**SAN ANTONIO WATER SYSTEM
LIFT STATIONS REHABILITATION DESIGN - PHASE 3
SAWS Job No. 08-2504
Solicitation No. B-12-015-MF**

ADDENDUM NO. 4

June 6, 2012

NOTES	INITIALS	DATE
DESIGNED BY	CC	10/07/11
REVIEWED BY	AL	10/07/11
SCALE:	AS SHOWN	
SHEET NO.	E-245-2 69 OF 143

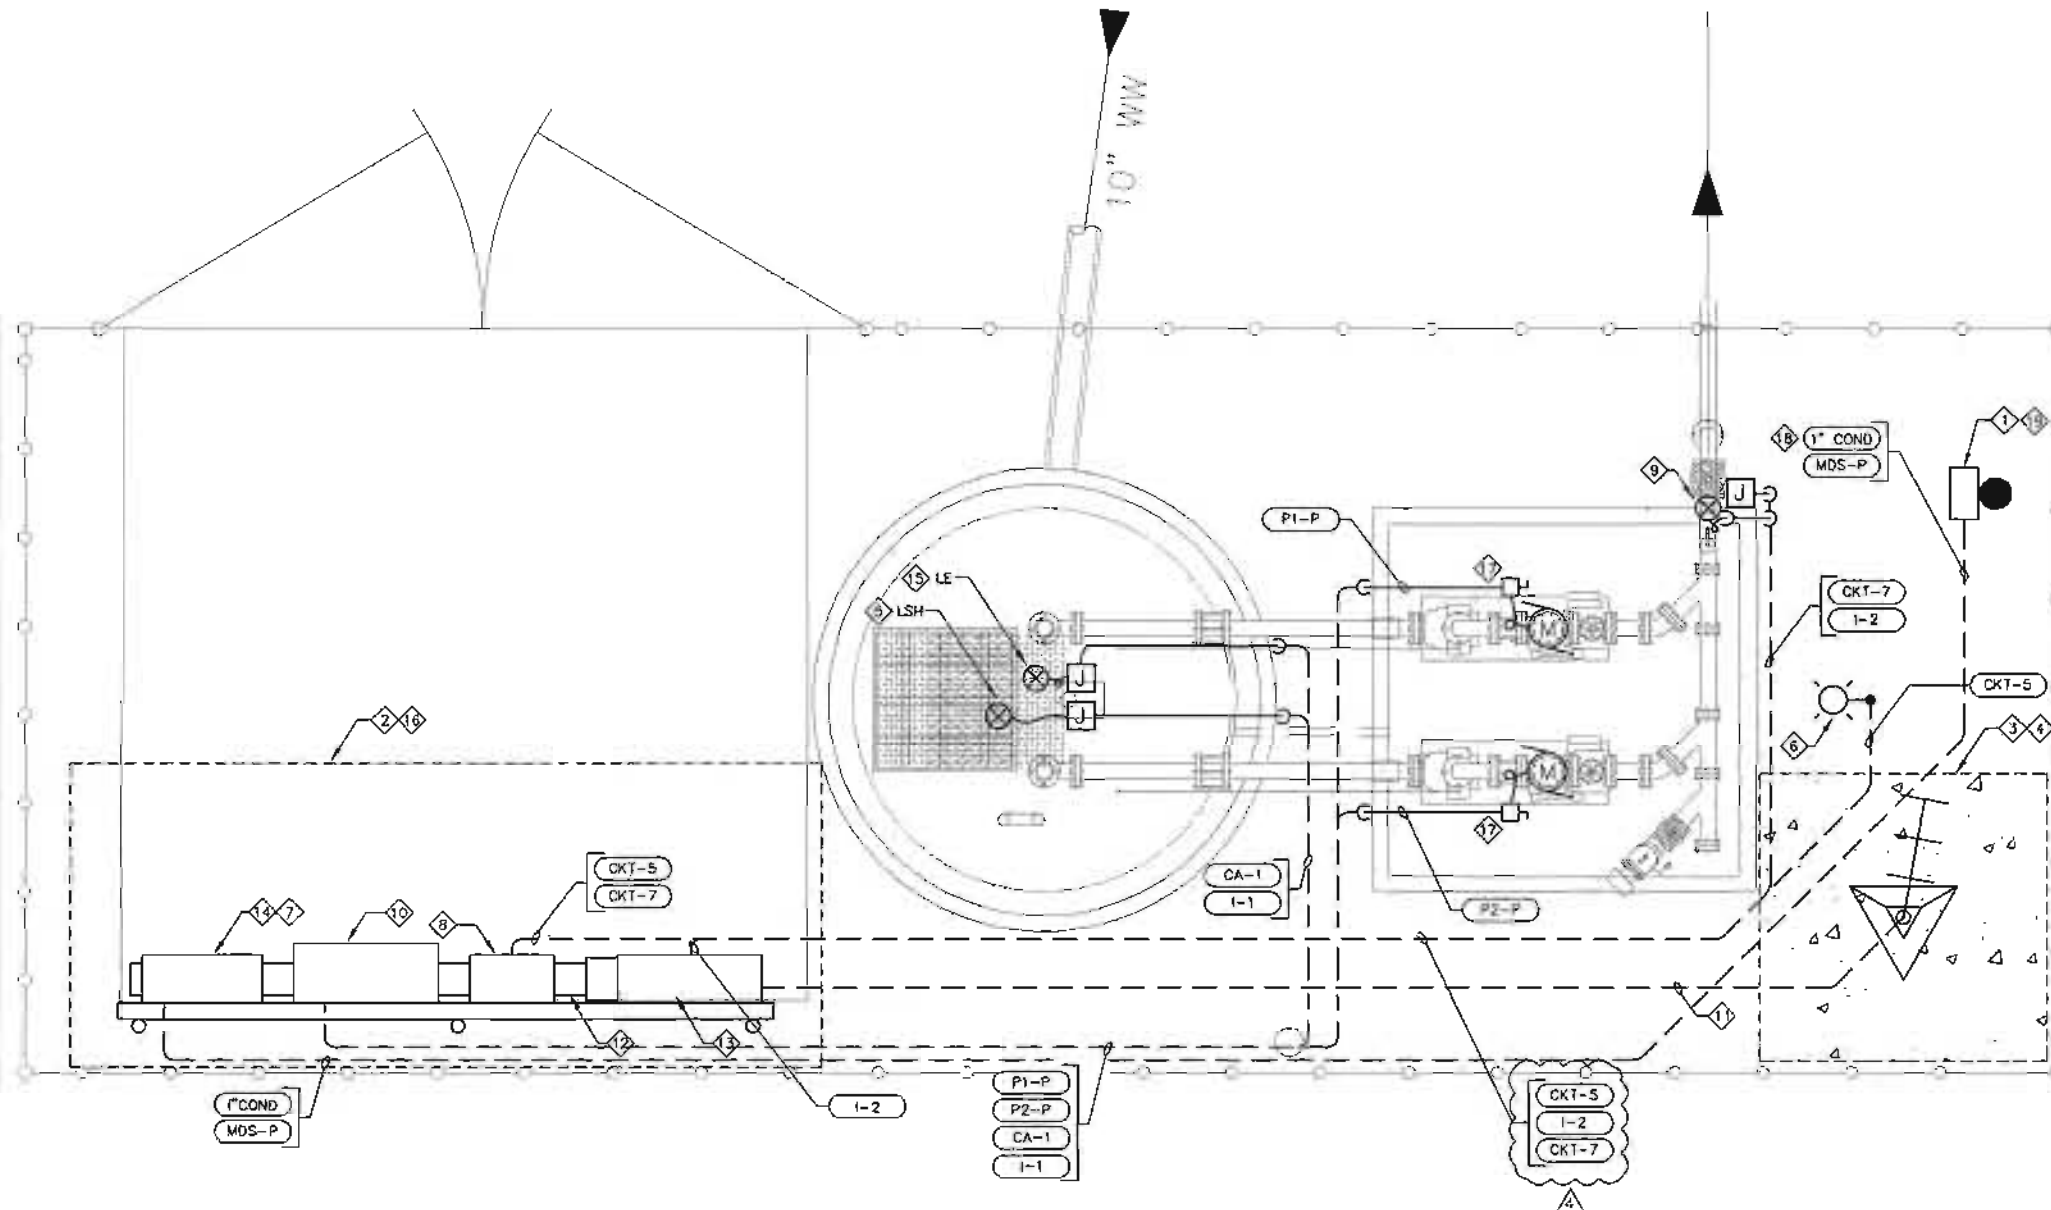
Item 1: LS# 245: Electrical Plan

- a) DELETE Sheet E-245-2, Sheet 69 of 143 and REPLACE with attached revised sheet dated 05/18/2012.

NOTES	INITIALS	DATE
DESIGNED BY	CC	1/17/12
REVIEWED BY	AL	1/17/12
SCALE:	AS SHOWN	
SHEET NO.	E-252-2	
	75 OF 143

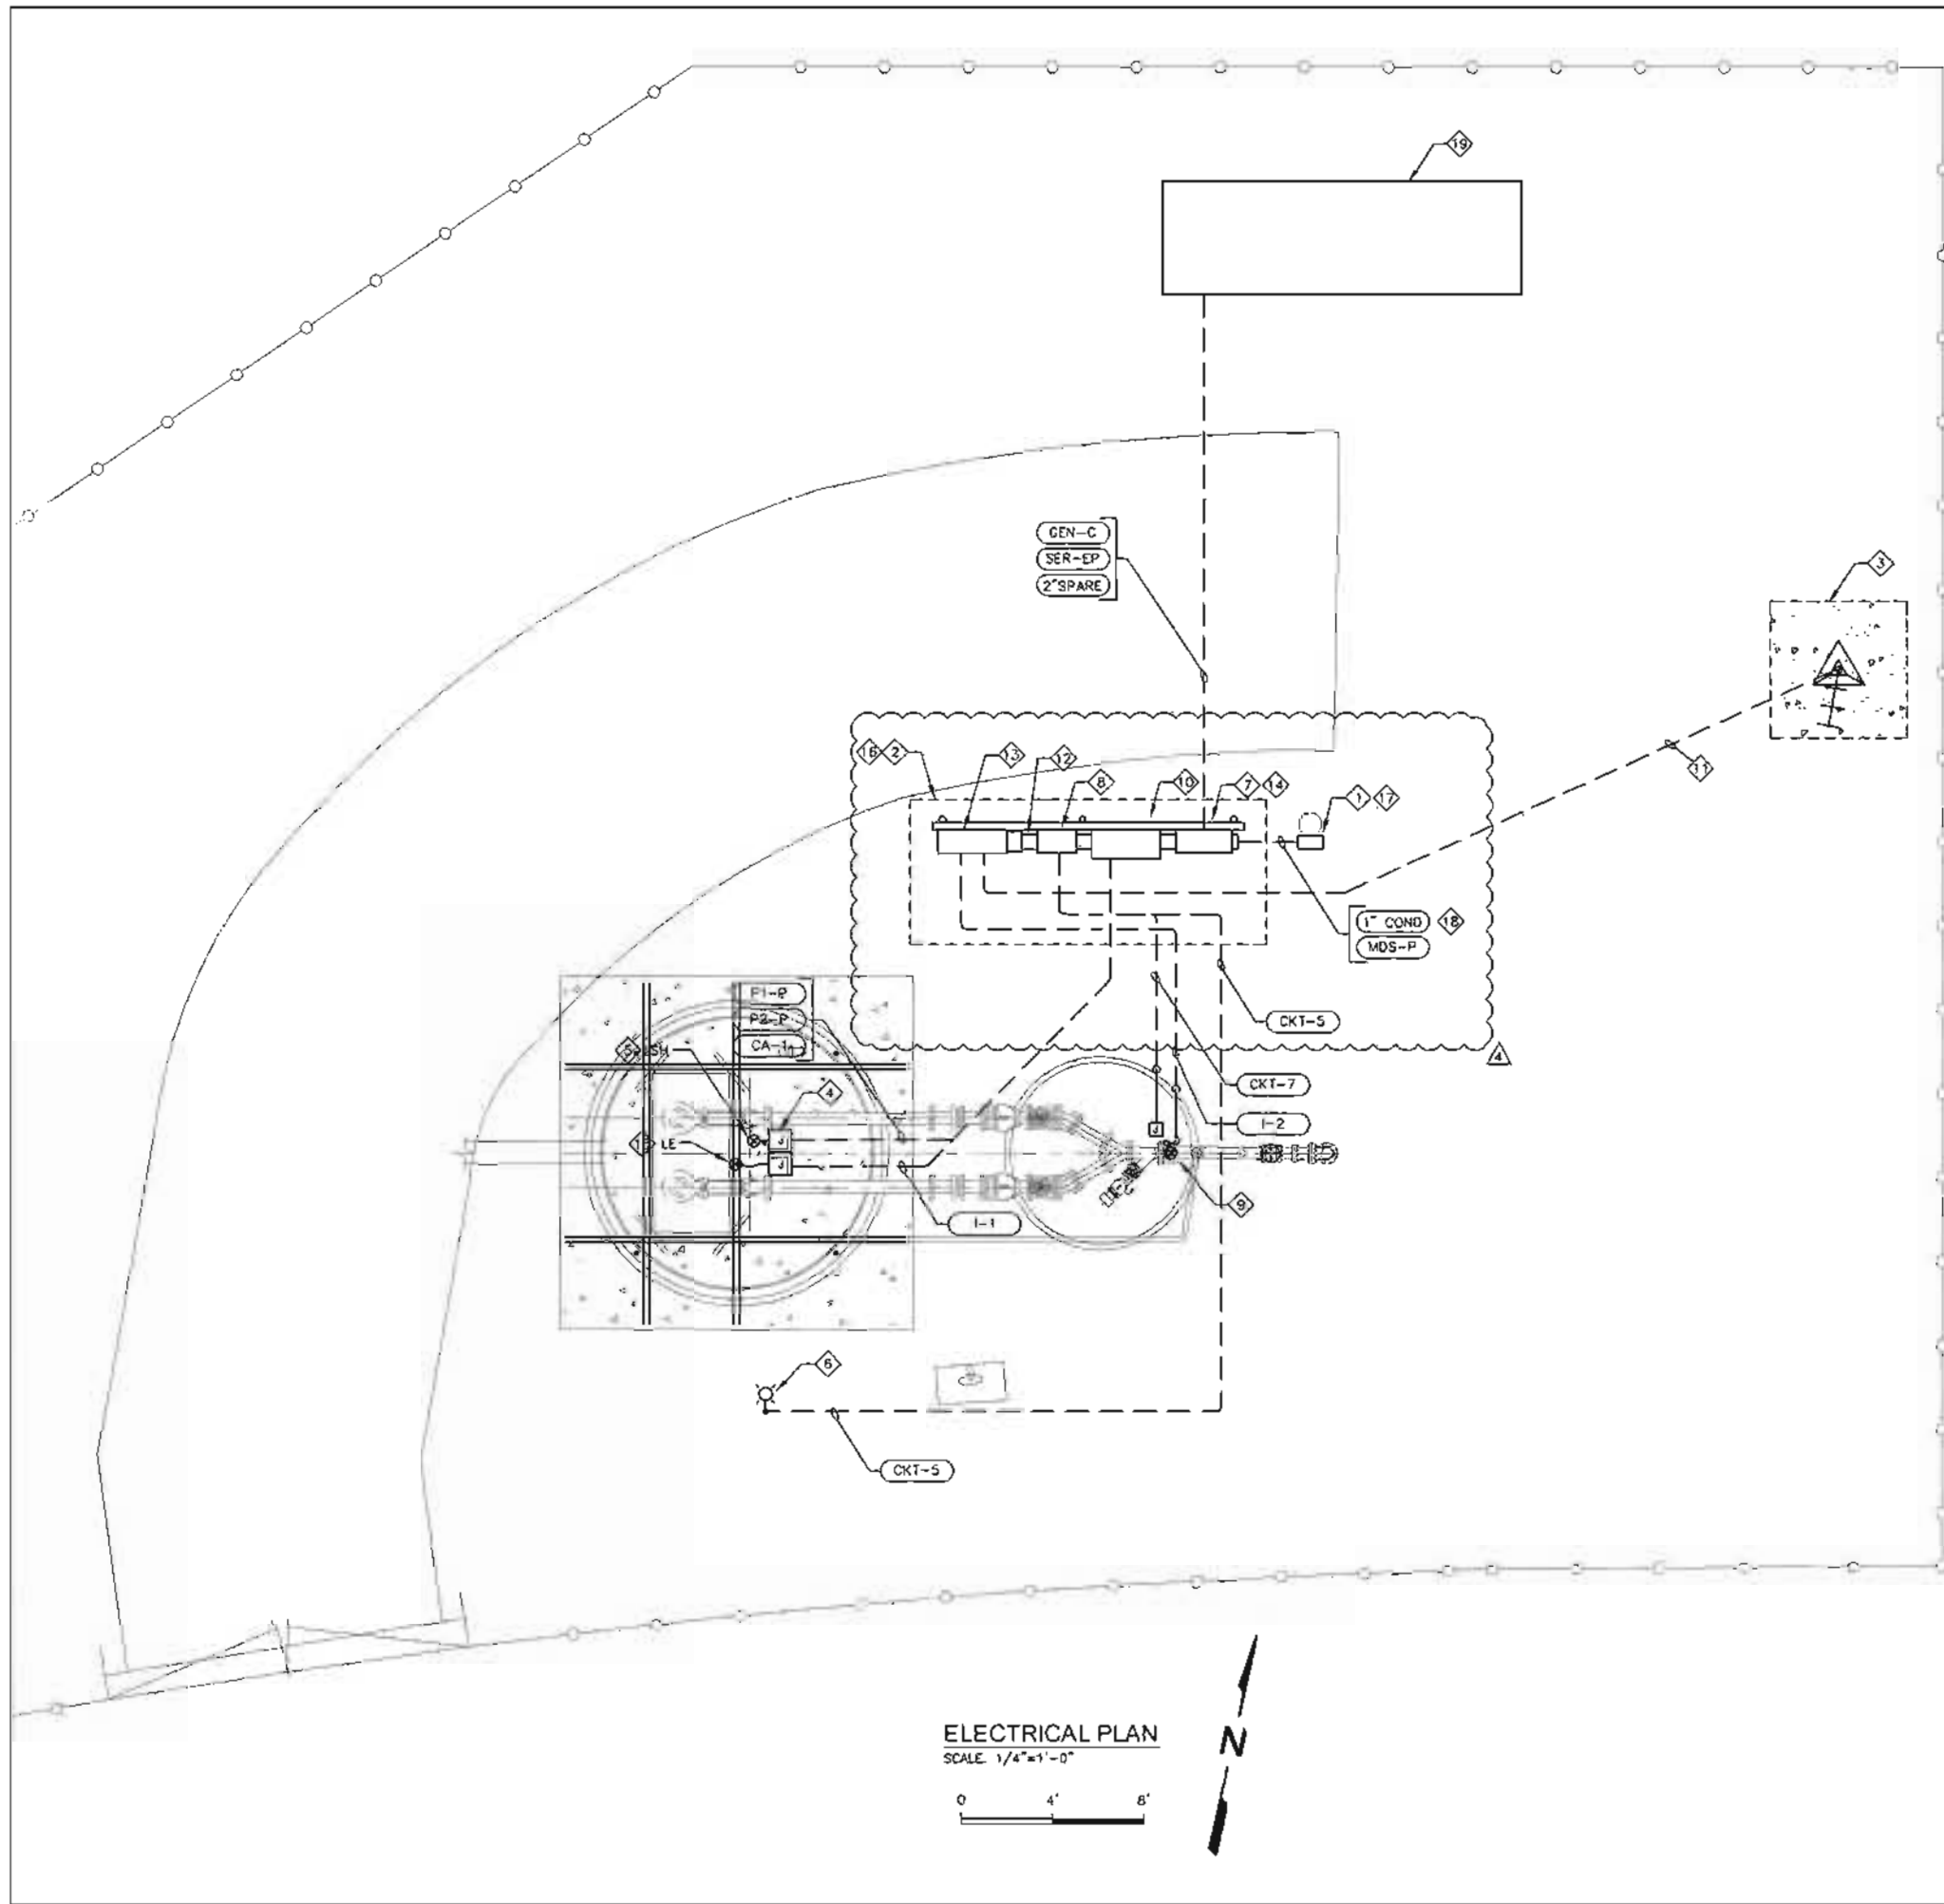
Item 2: LS# 252: Electrical Plan

- a) DELETE Sheet E-252-2, Sheet 75 of 143 and REPLACE with attached revised sheet dated 5/18/2012.

SHEET NO. **E-253-1**
79 OF 143

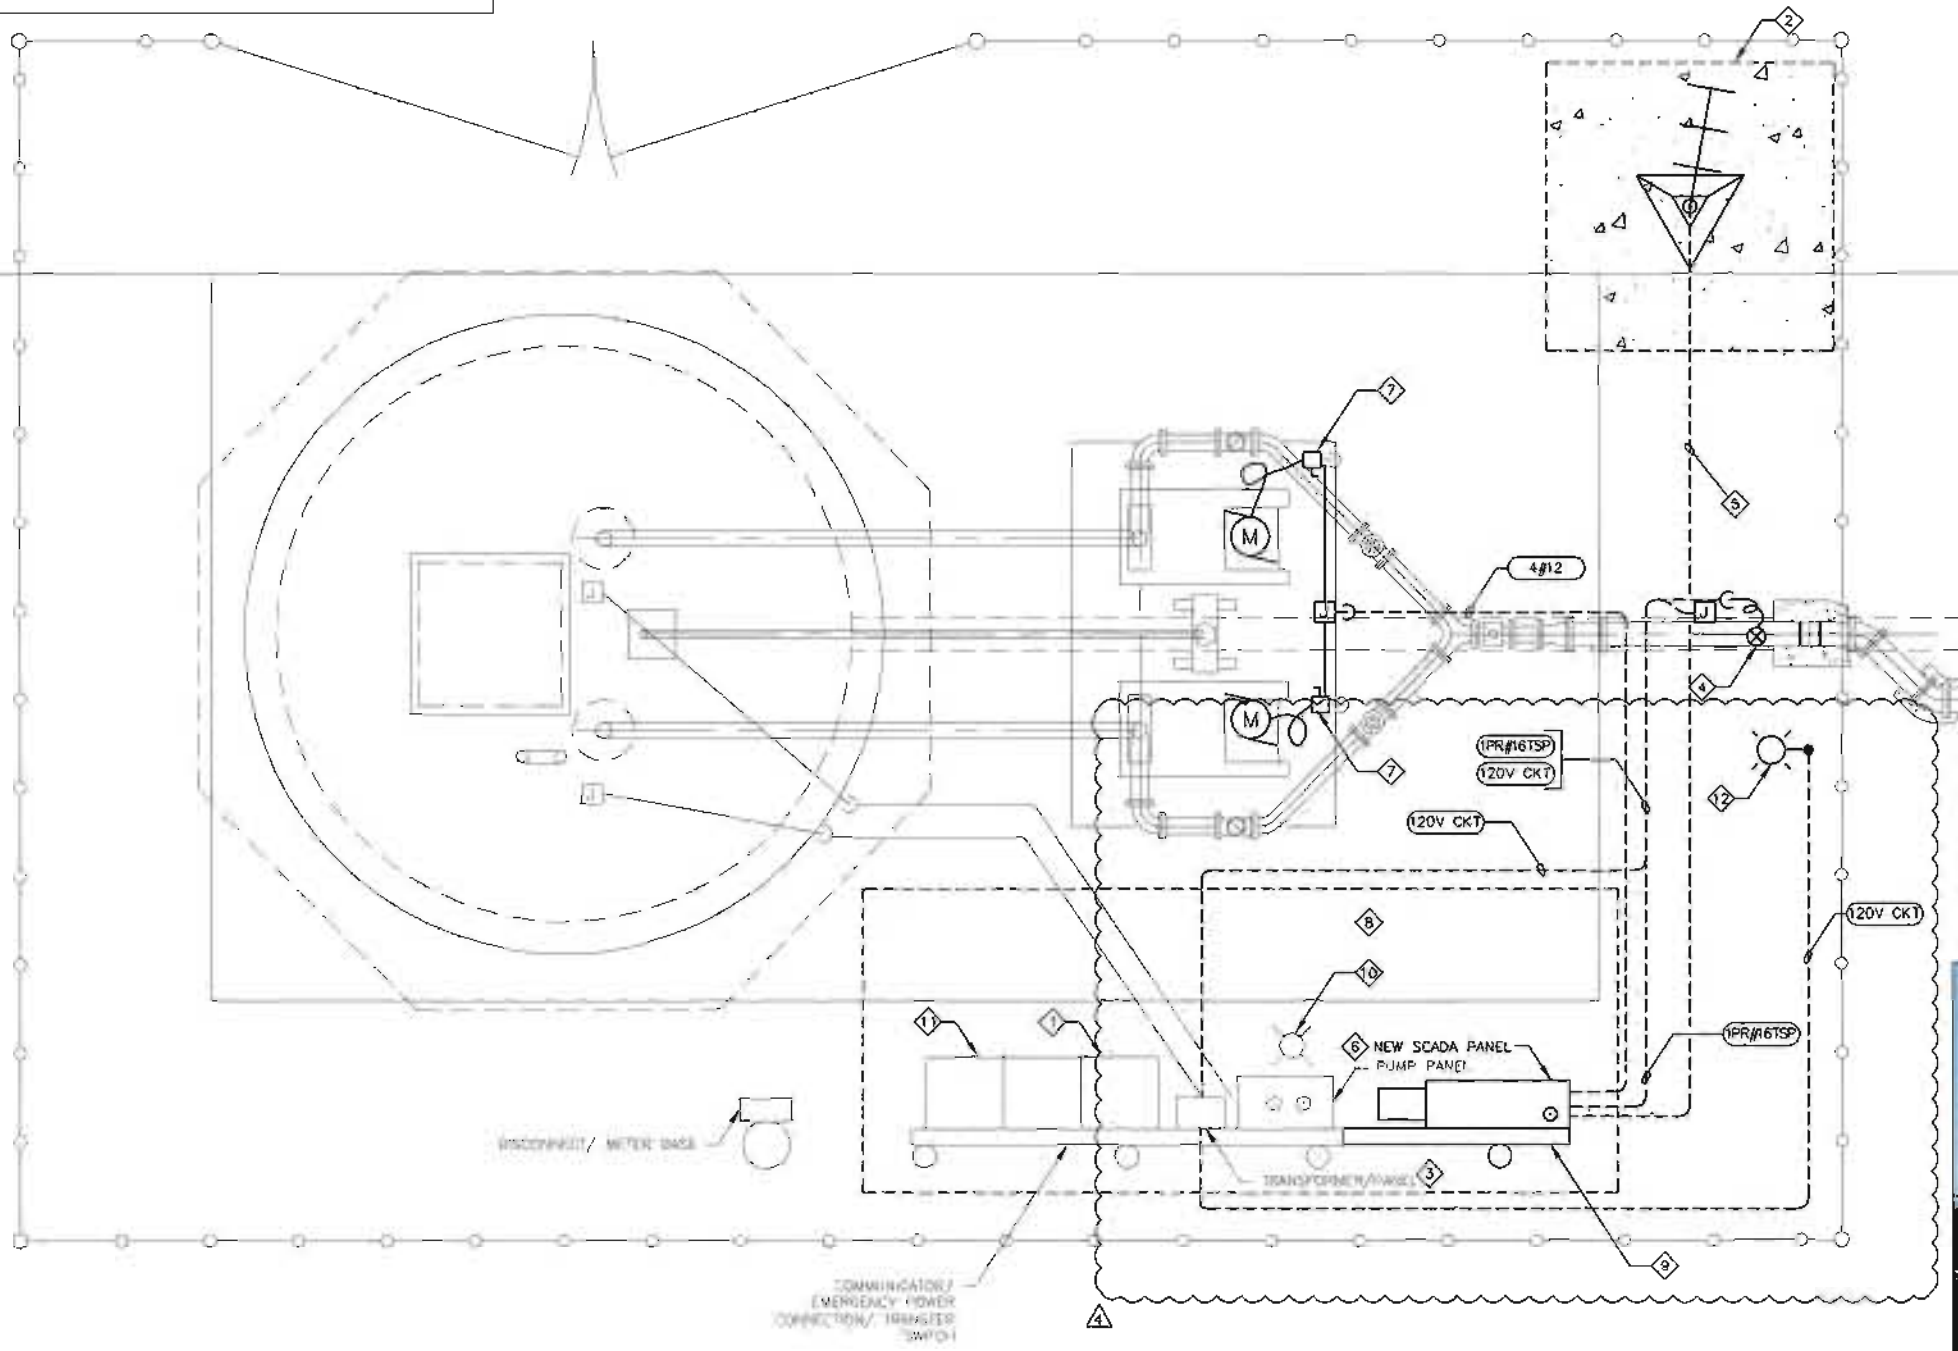
Item 3: LS# 253: Electrical Modifications Plan

- a) DELETE Sheet E-253-1, Sheet 79 of 143 and REPLACE with attached revised sheet dated 5/18/2012.
